**Subject:** ELST South Samm B Comments for the Comment Record - 14 individual emails  
**Attachments:** Please Approve the Permit for Segment 2B of the ELST; Please Approve the Permit for Segment 2B of the ELST; Please Approve the Permit for Segment 2B of the ELST; Please Approve the Permit for Segment 2B of the ELST; Please Approve the Permit for Segment 2B of the ELST; Please Approve the Permit for Segment 2B of the ELST; Please Approve the Permit for Segment 2B of the ELST; Please Approve the Permit for Segment 2B of the ELST; Please Approve the Permit for Segment 2B of the ELST; Please Approve the Permit for Segment 2B of the ELST; Please Approve the Permit for Segment 2B of the ELST; Please Approve the Permit for Segment 2B of the ELST; Please Approve the Permit for Segment 2B of the ELST; Please Approve the Permit for Segment 2B of the ELST

Lindsey please let me know if you have any difficulty opening these emails. These are individual comments for the South Sammamish B SSDP.

East Lake Sammamish  
 Master Plan trail South  
 Sammamish Segment B  
 60% review

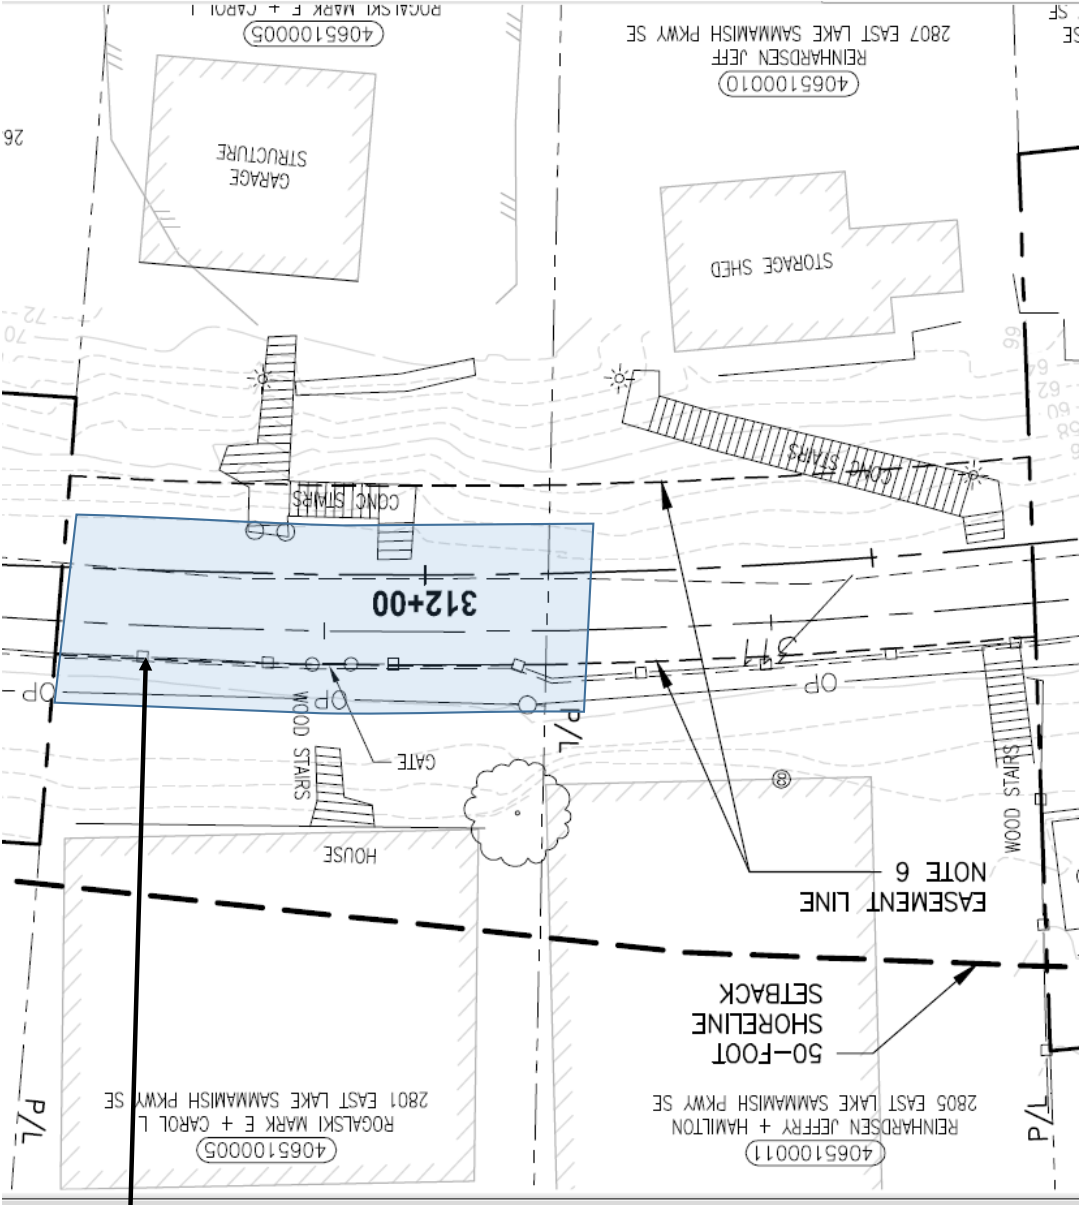
Garage floor height is at 64 ft  
 and trail is proposed at ~ 51 ft

20 ft Easement not at center  
 line of removed tracks.

Excerpts from Quit Claim Deed, March 4, 1999 easement agreement.

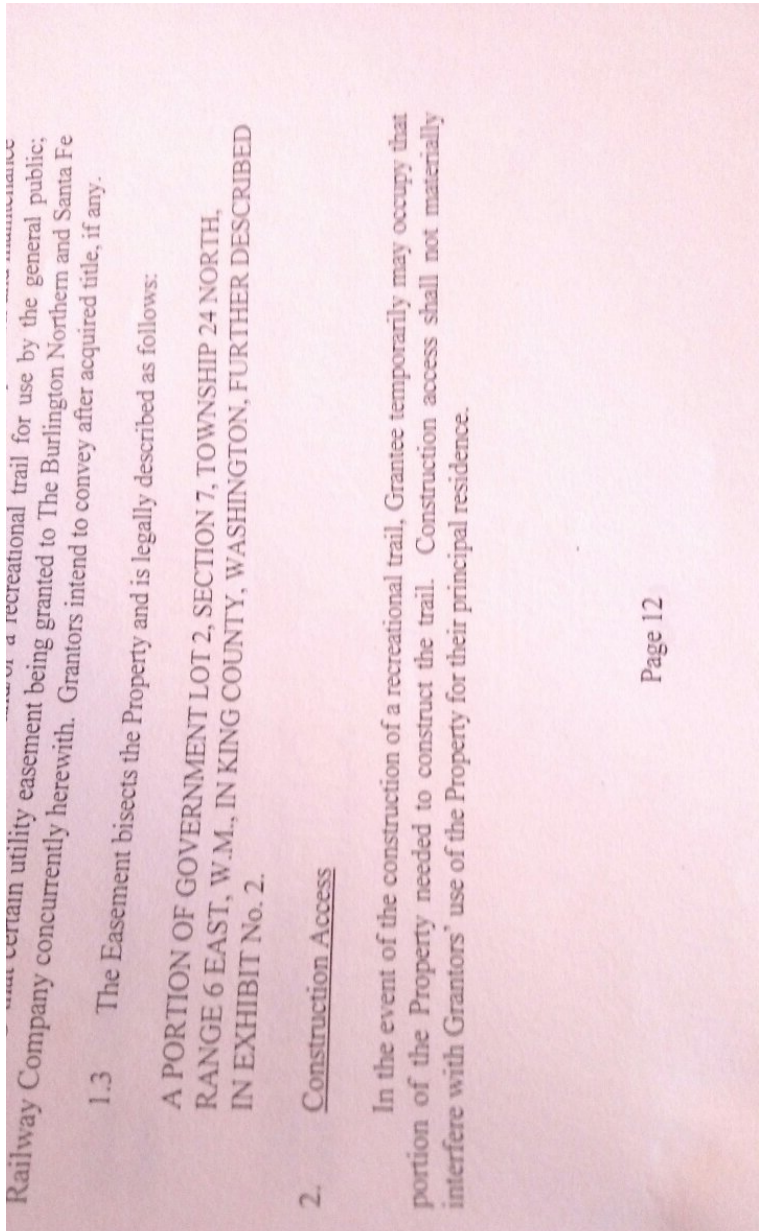
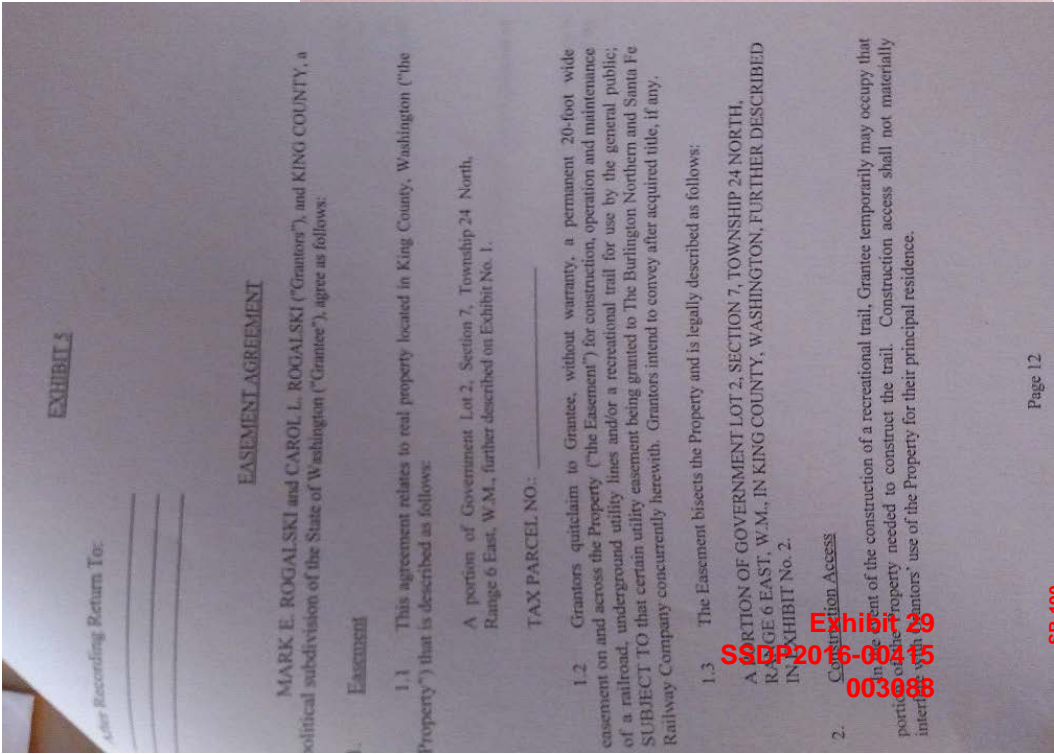
Clarify construction requirements to have access during construction of trail improvements.

Sheet 39 of 135 (East)  
 Lake Sammamish Master  
 Plan trail South  
 Sammamish Segment B  
 60% review

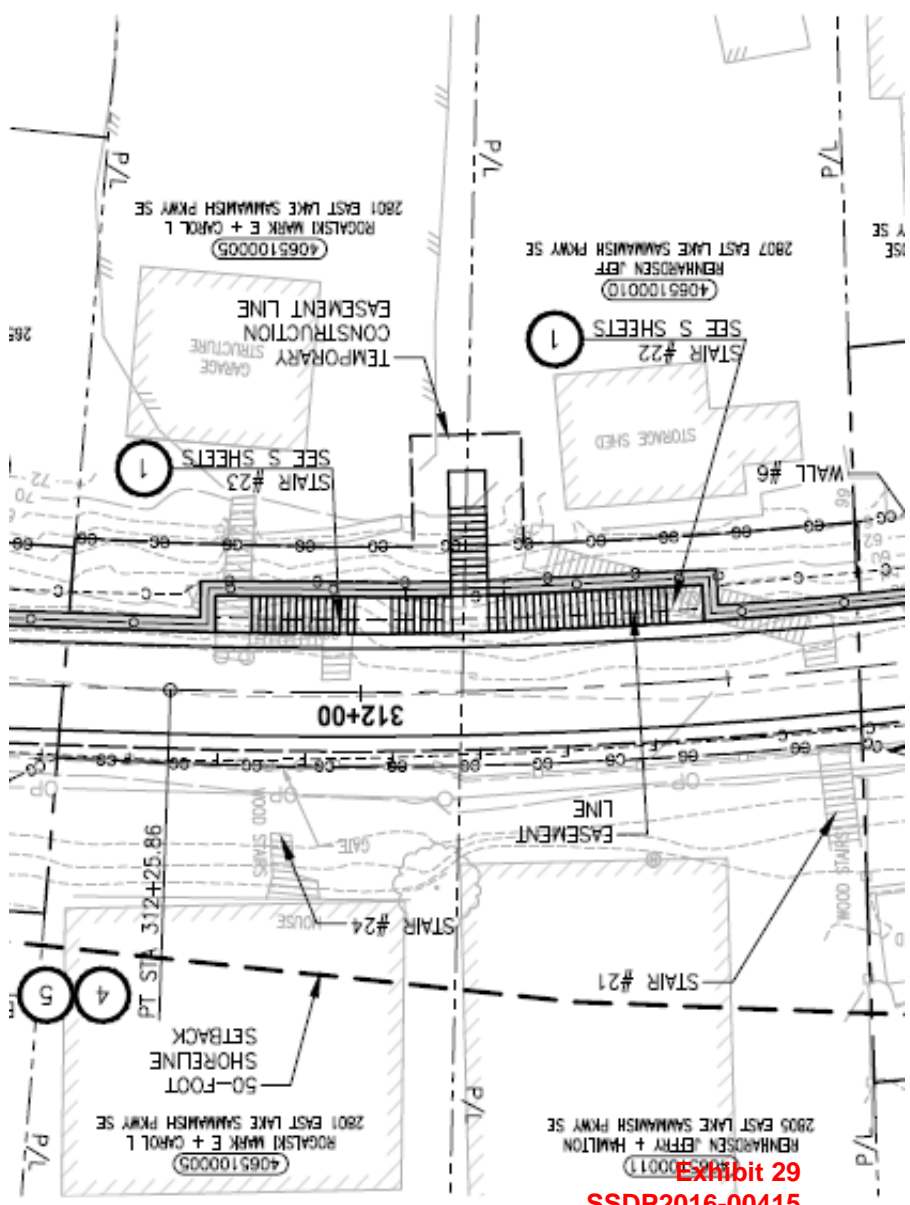
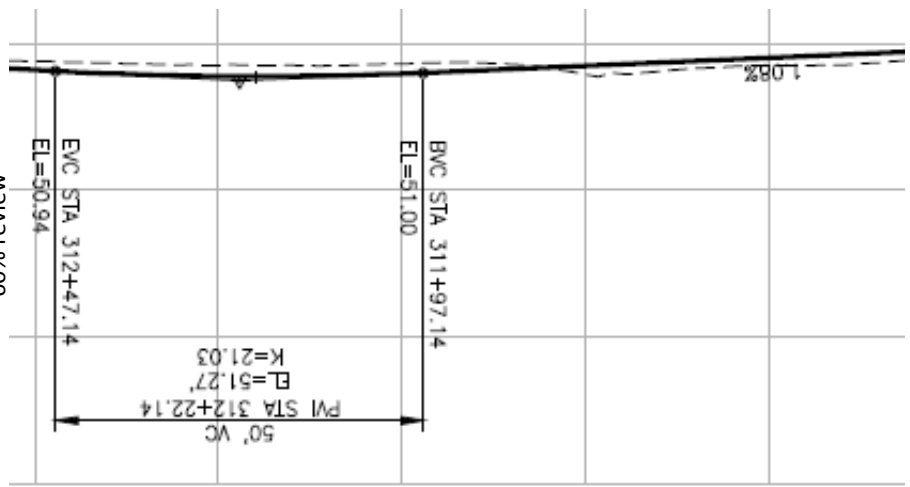
**60% Plan showing only a single combined access for top elevation for two properties on property line. These are separate properties. Privacy is an attribute for these properties. Currently there is no easy access from the Reinhardtsen property to our upper garage without going way around for visitors of both households.**

SB-190

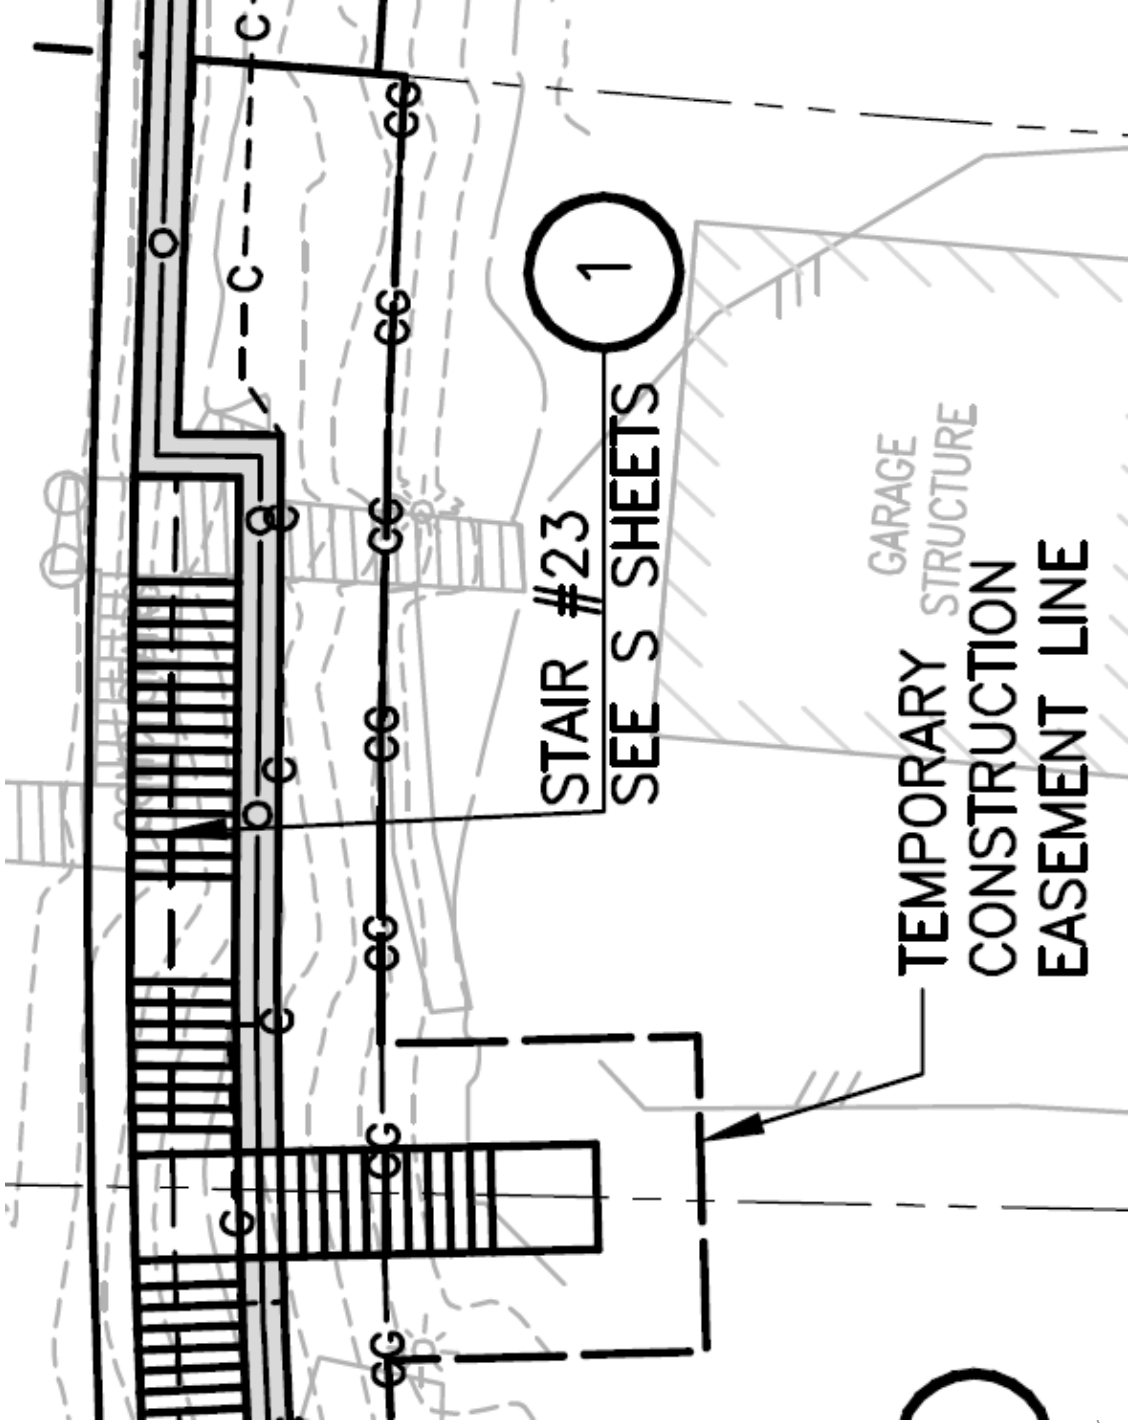
Platform need to at least 10 feet above trail and capable of supporting a bridge or bridge attachment is higher.

Staircase is not aligned with garage door for future bridge. A separate stairs allows this and avoids other conflicts of height and property separation.

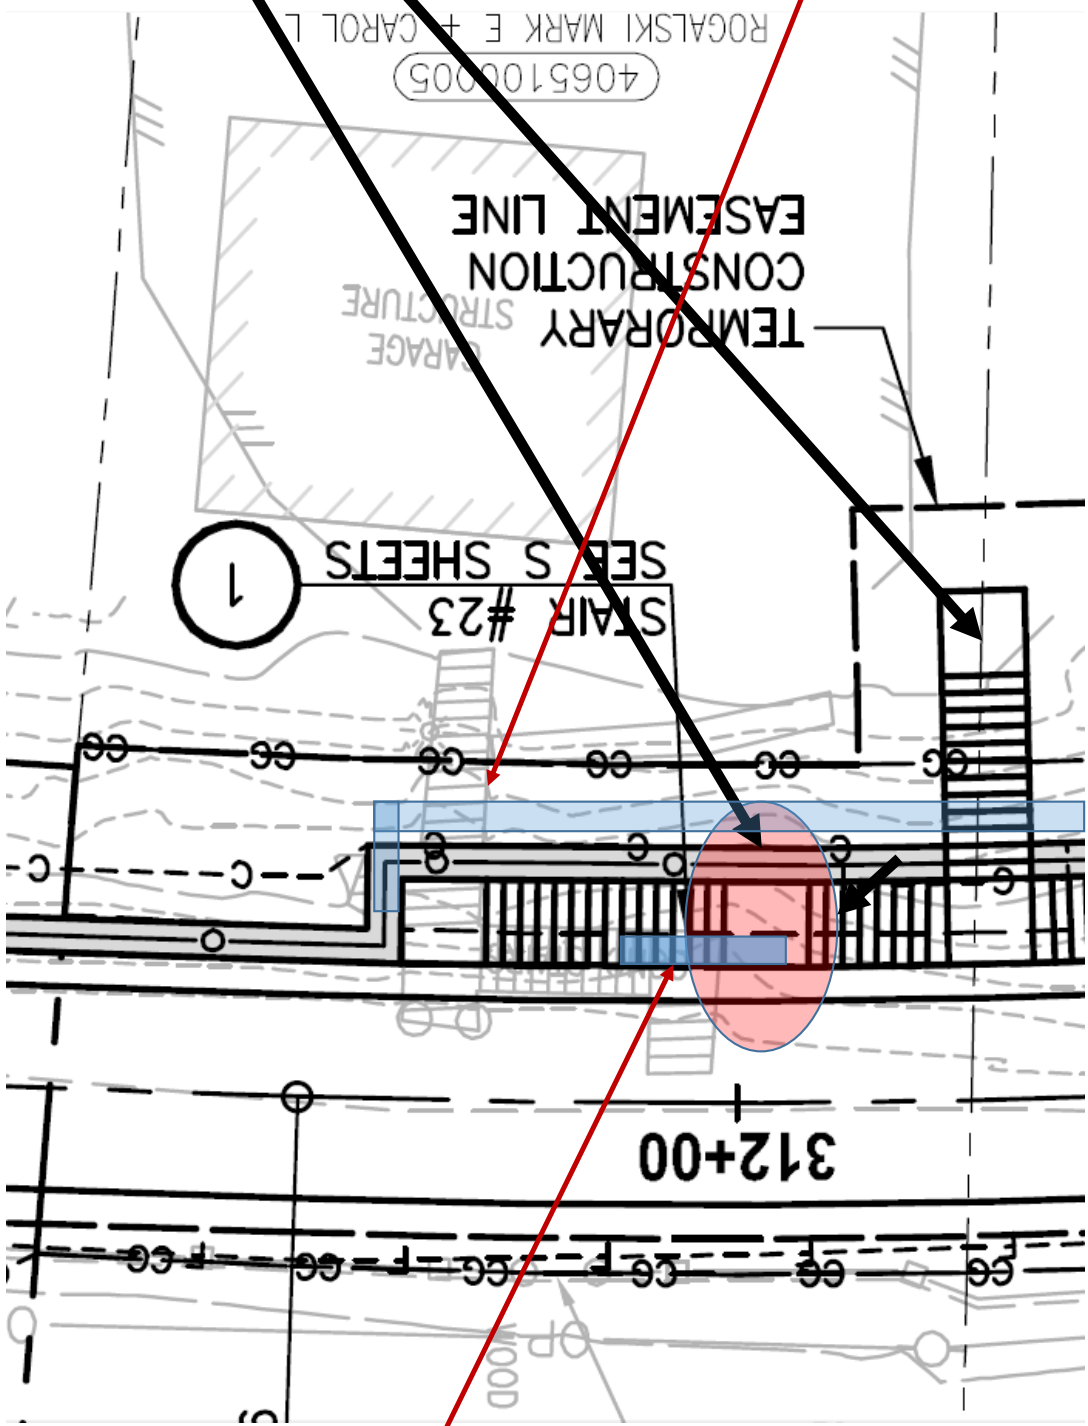
**Engineering options for discussion.** Stairs could be brought into the hillside more than indicated and a base footing at trail height Footing could be inserted in front of the wall to accommodate supporting pillars to support a bridge as a option or the platform could be made larger with capability to support the bridge structure at the correct height. Stairs can go either direction to accommodate single property access. Platform size will also need to be discussed.

Support footing with pillar attach anchors in front of wall to attach pillars to support overpass. (option concept)

Wall #6 Wall Profile

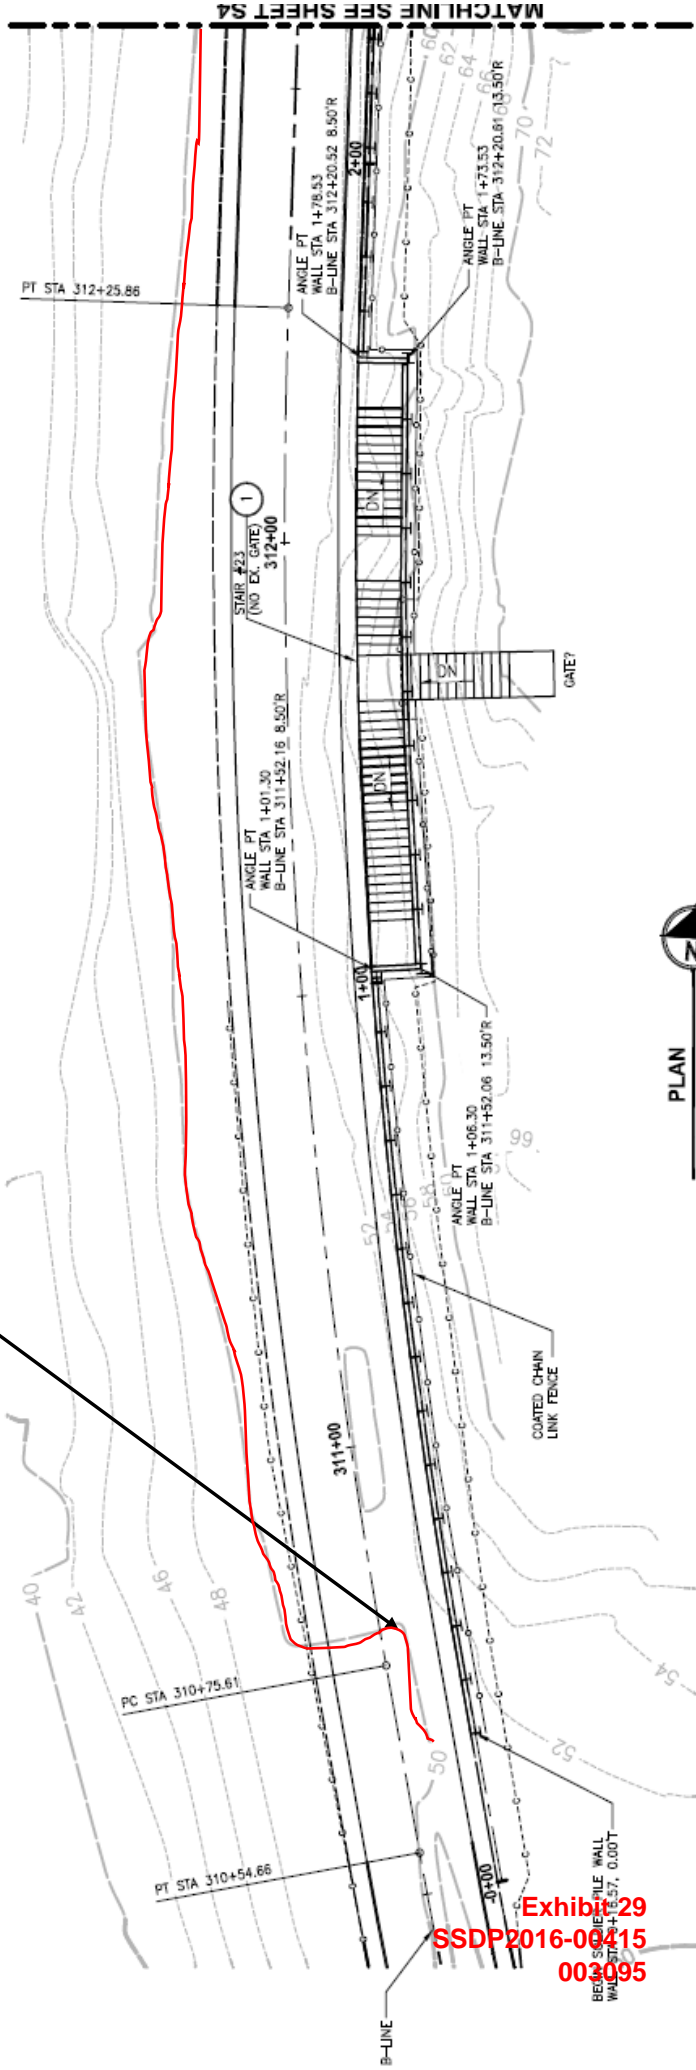
Elevations are not consistent with previous surveys. Easement elevation is at 46- 47 feet and not at 50 feet as shown on these plans. Center line of Easement is at 46.9 Ft.

Wall #6 Wall Profile

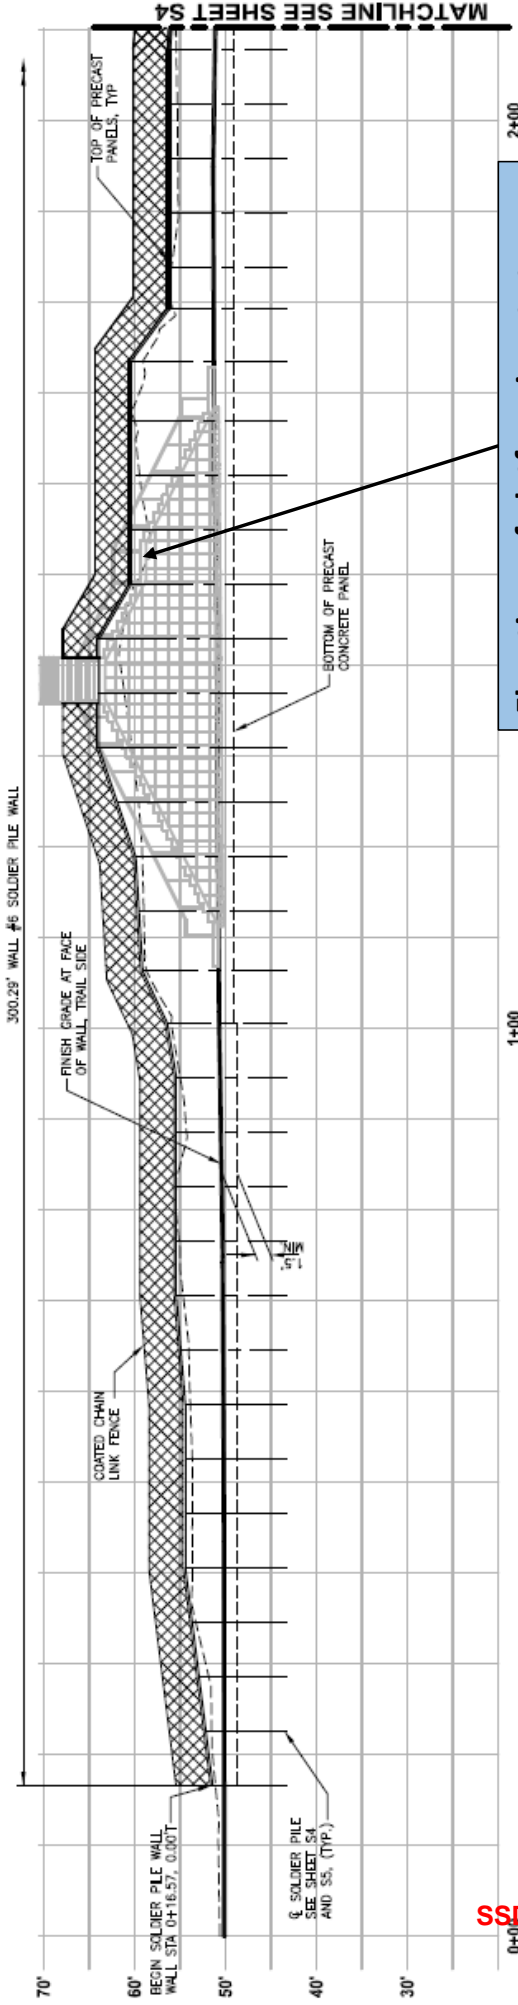
**Elevations are not consistent with previous surveys. Easement elevation is at 46- 47 feet and not at 50 feet as shown on these plans. Center line of Easement is at 46.9 Ft. Needs correction to assure elevations are consistent with current grade within reason of conversion to a trail. Plans for bridge are relative to existing trail/Grade height. Correct/reconcile elevations and provide drainage plan.**
